1. SUBMITTAL TYPE: (Is this a resubmittal? Yes ☐ No ☒)			
Deferred Submittal ☐	Addendum Number: 01	Revision Number:	CCD Number: Category A ☐ or B ☐
2. PROJECT INFORMATION:			
School District/Owner: San Beranrdo City USD		DSA File Number: 36 H7	
Project Name/School: Indian Springs HS - Health Center		DSA Application Number 04 123900

ADDENDUM NO. 1

Indian Springs High School – Health Center

DSA #04-123900 FILE #36-H7 RCA Project No. 1-78-50

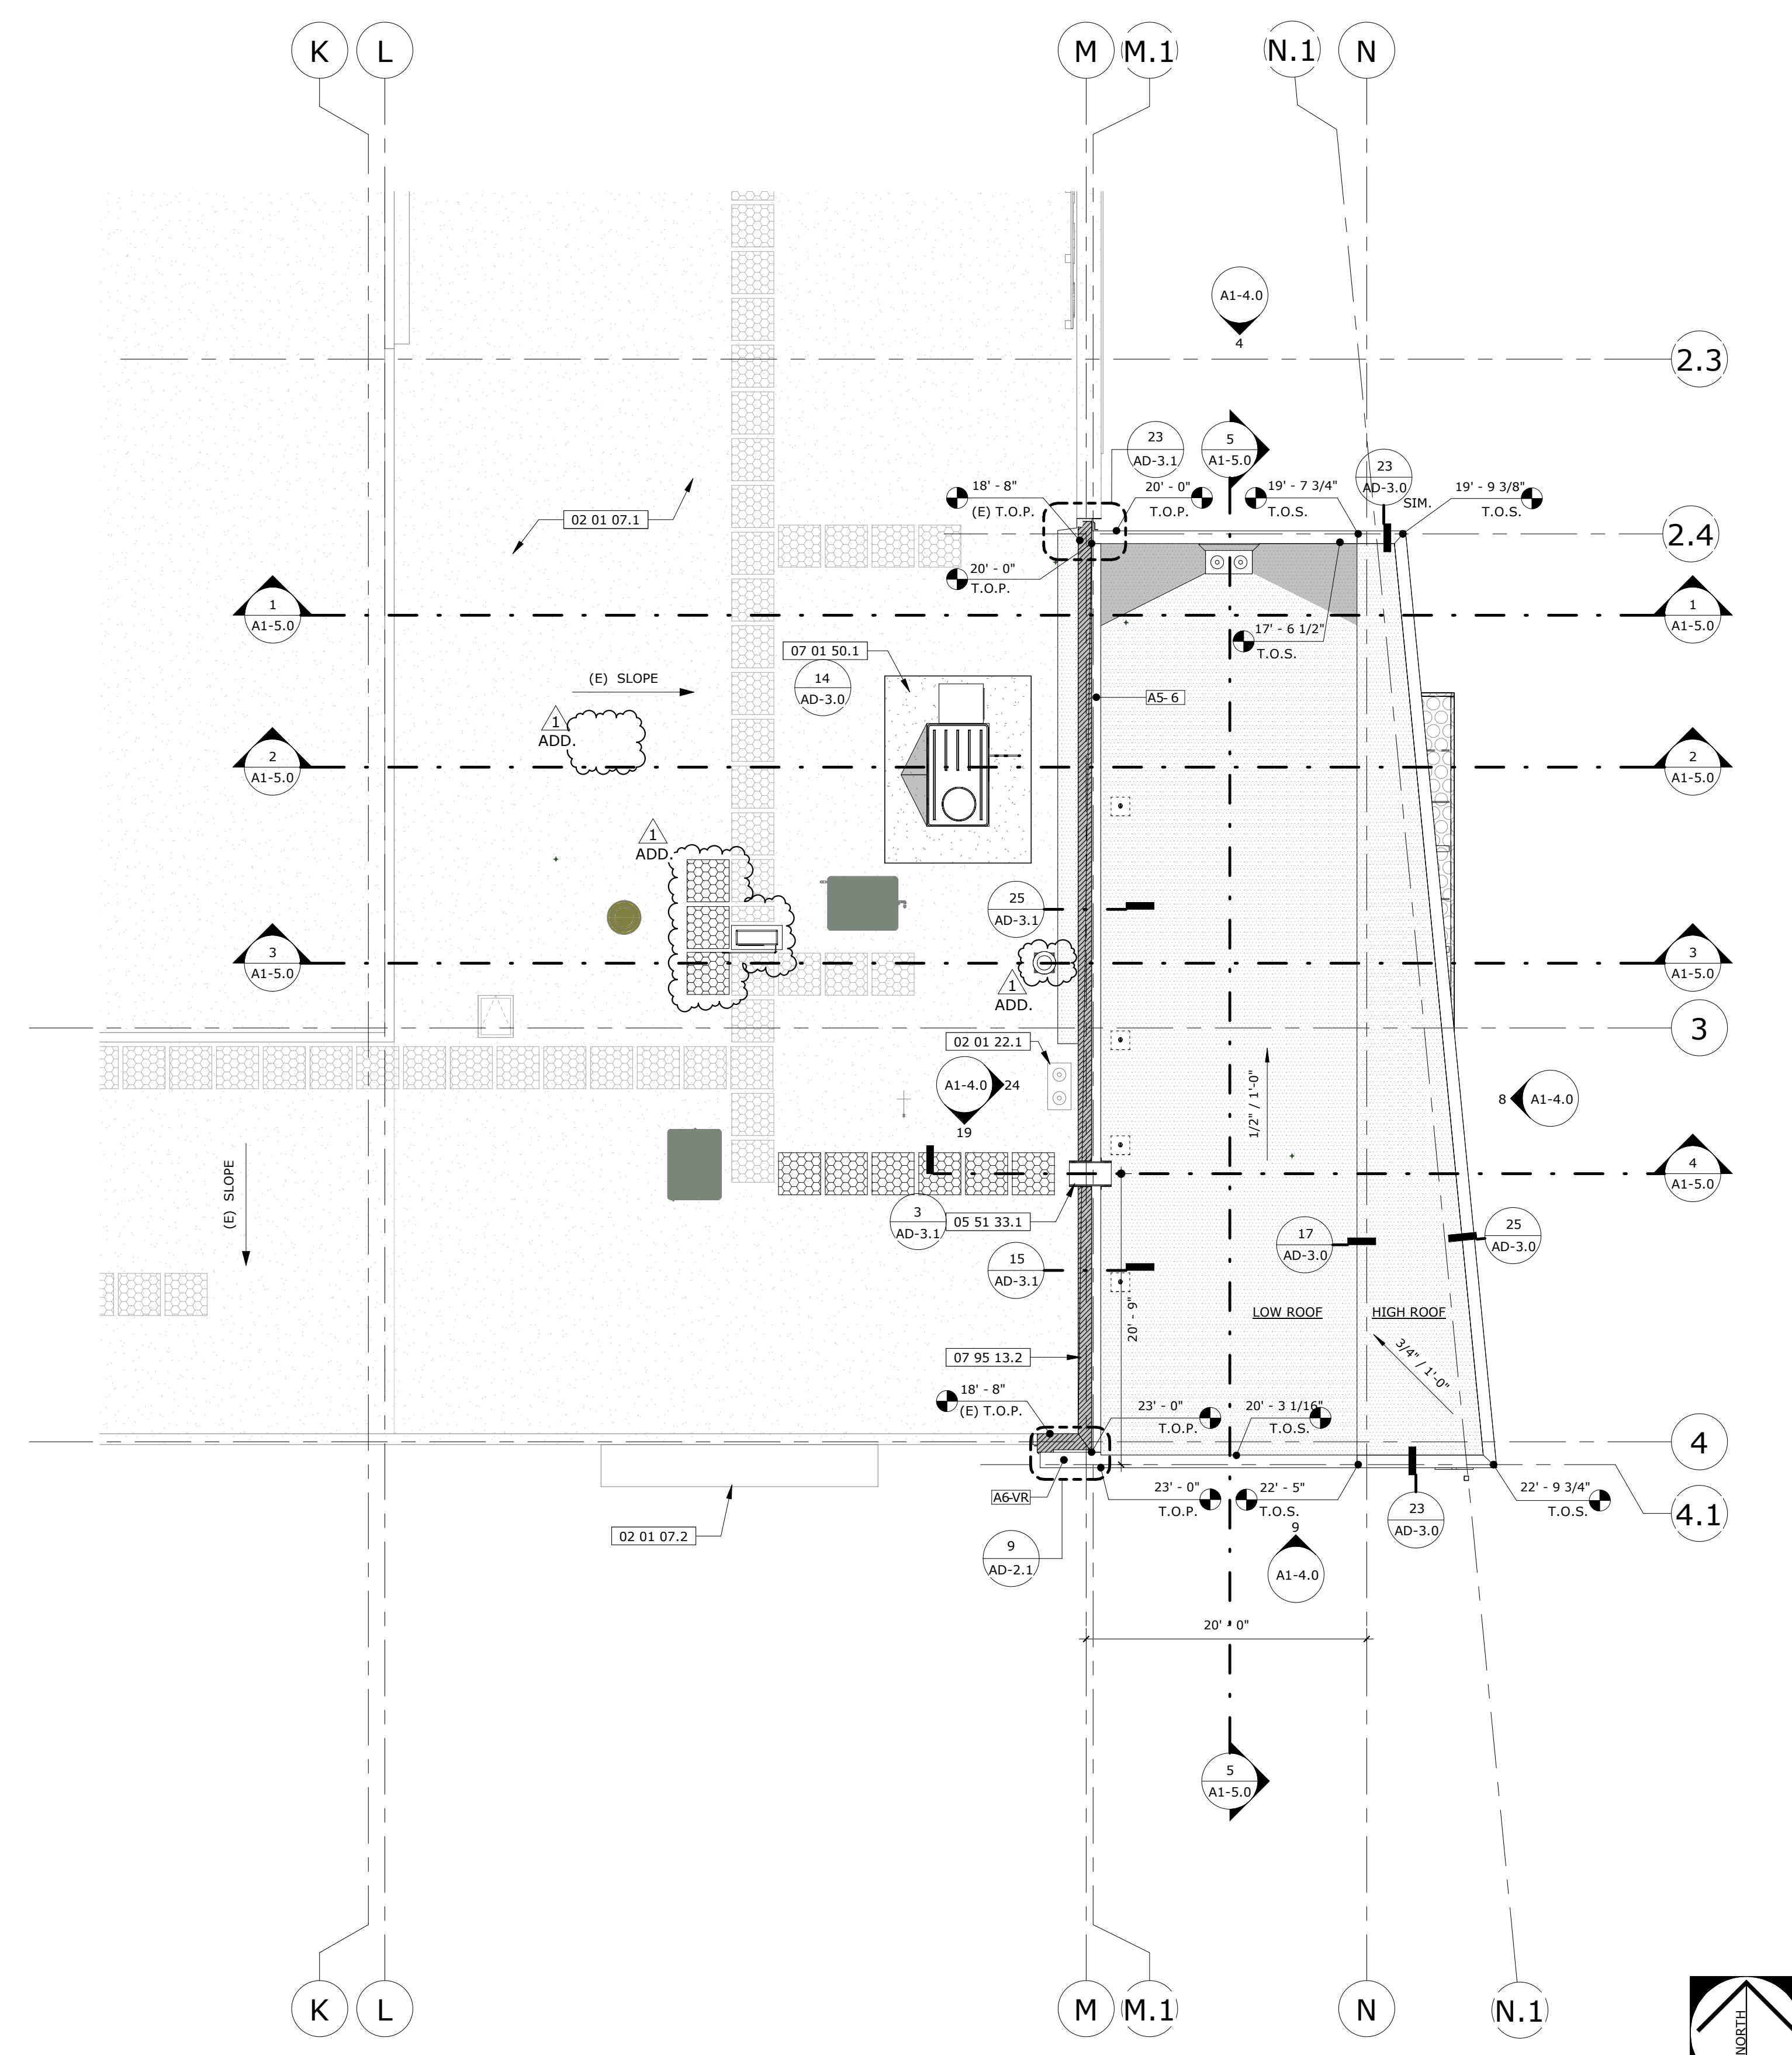
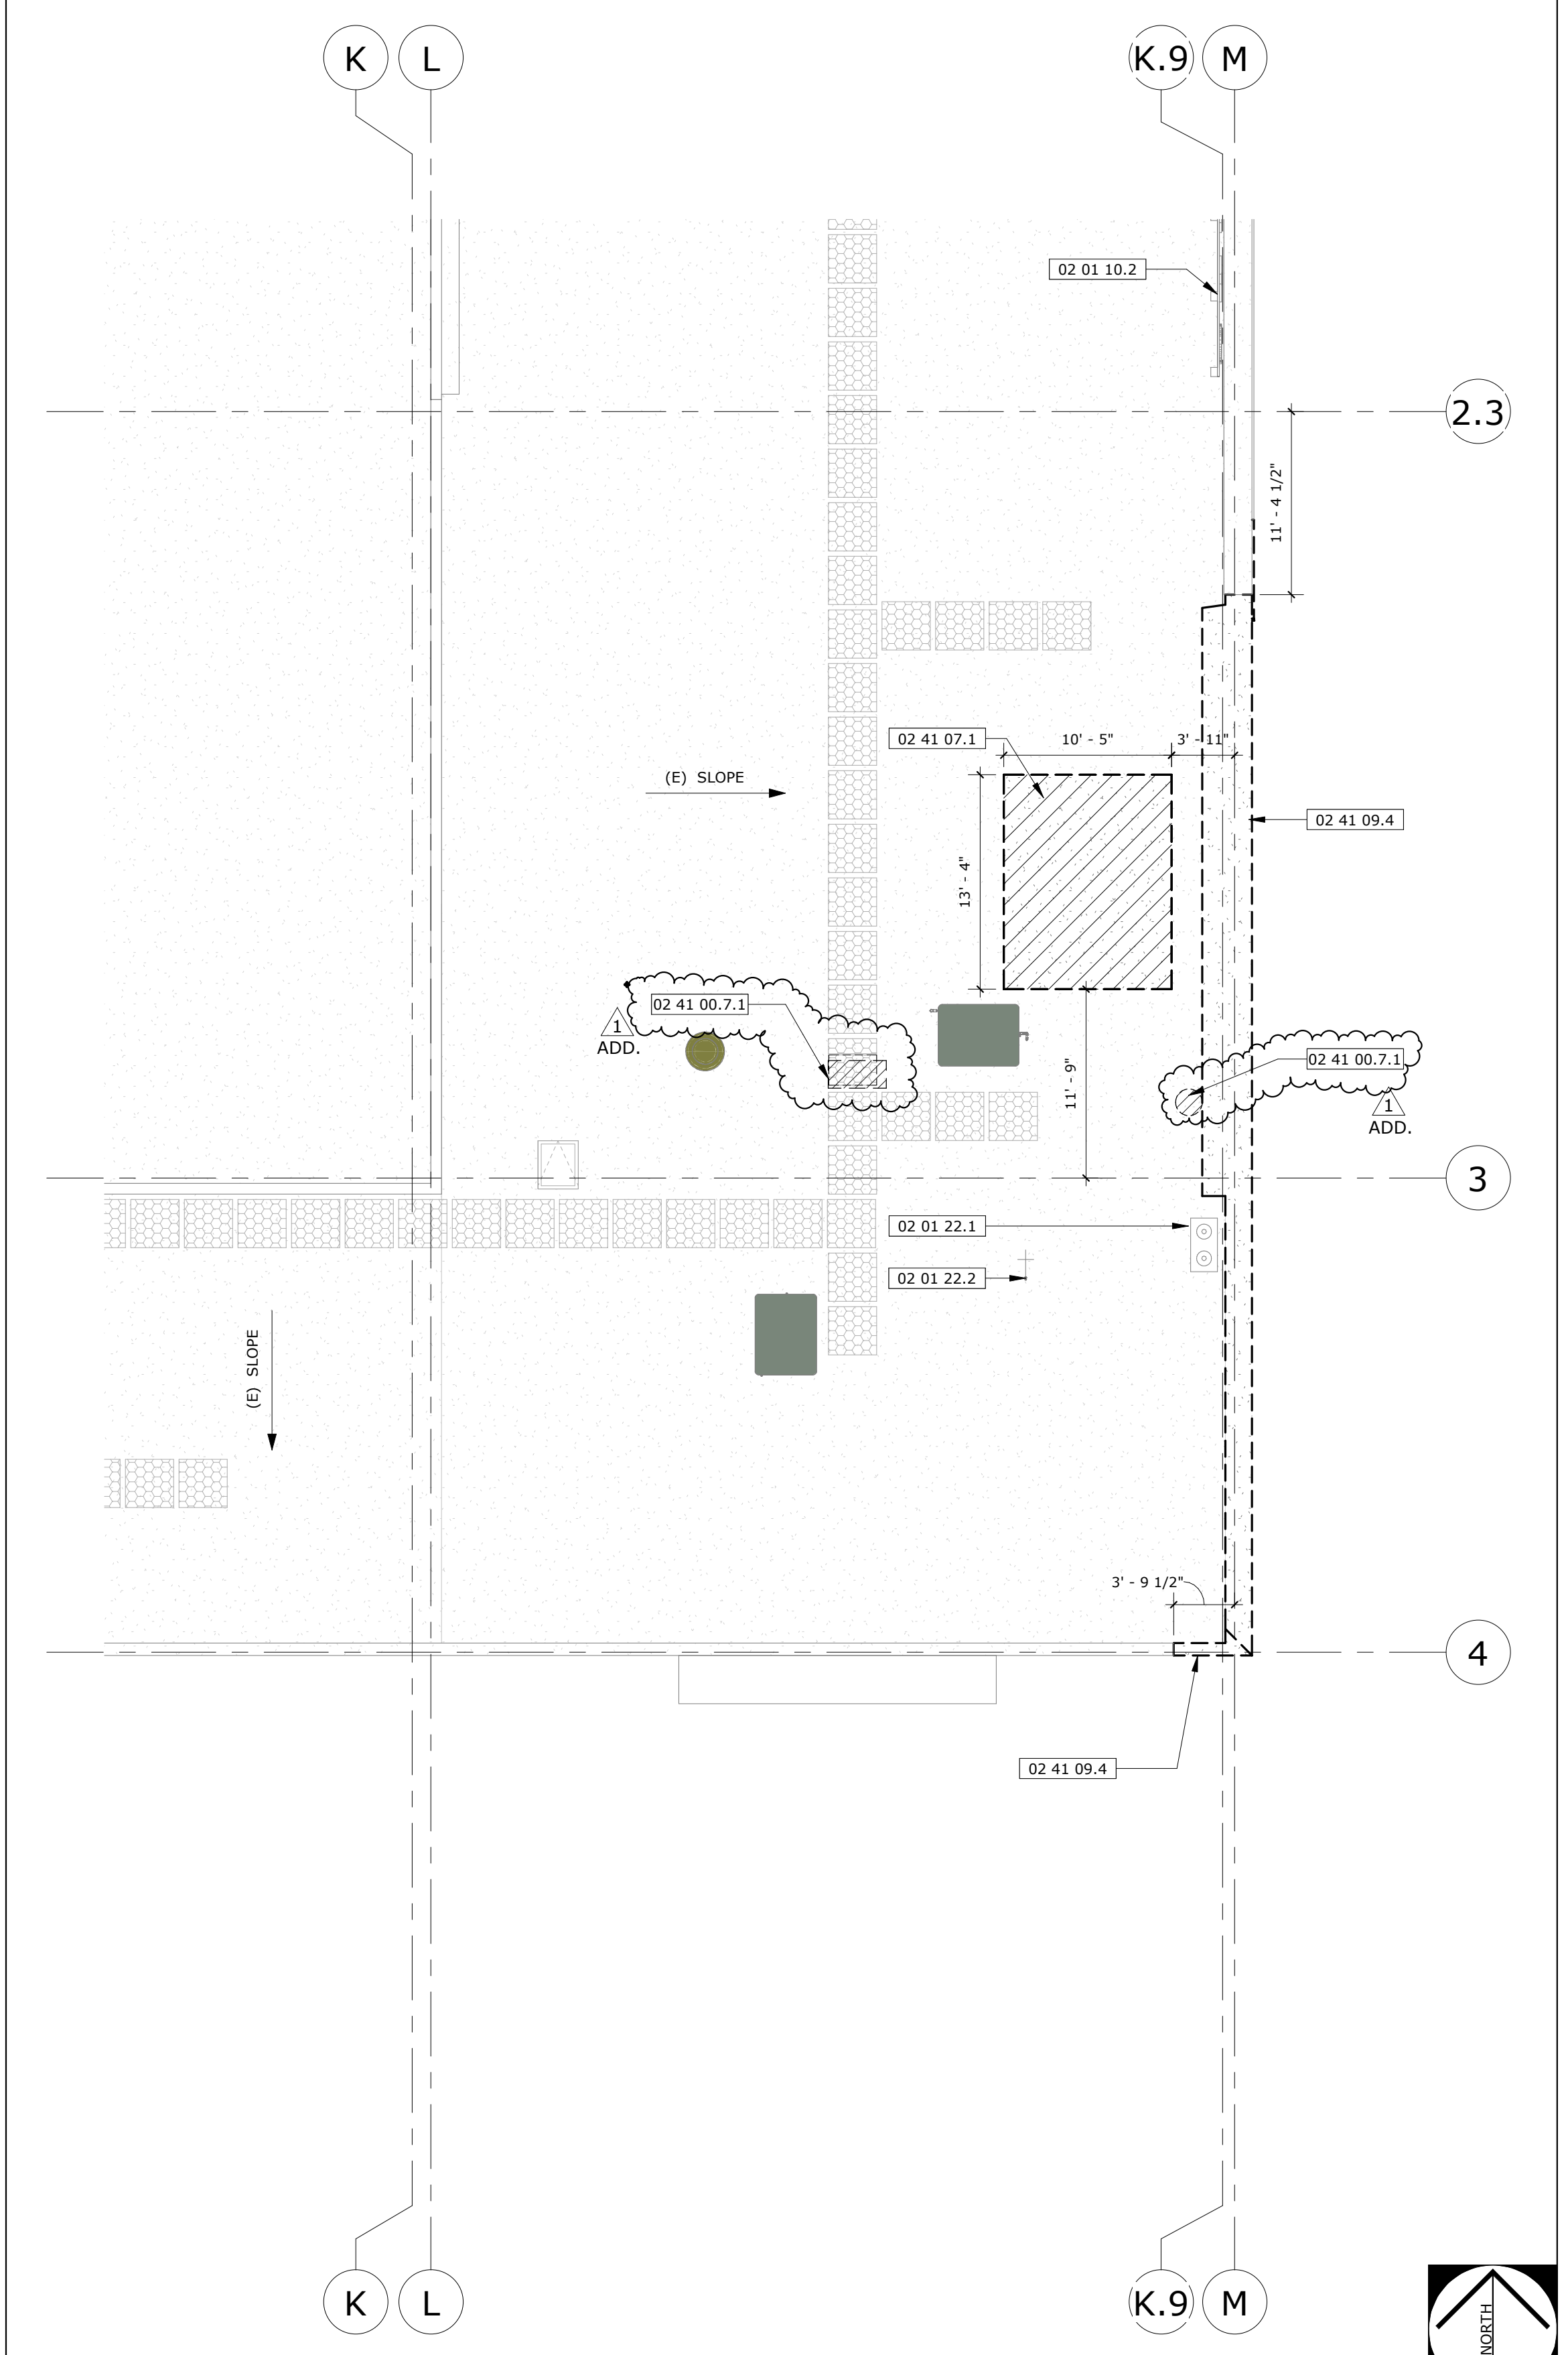
(a) Revised roof plan to match updated mechanical layout
- Item No. 1.12 Reference Sheet A1-5.0 – BUILDING SECTIONS
1.12.1 Replace Sheet A1-5.0 and revise per clouded areas
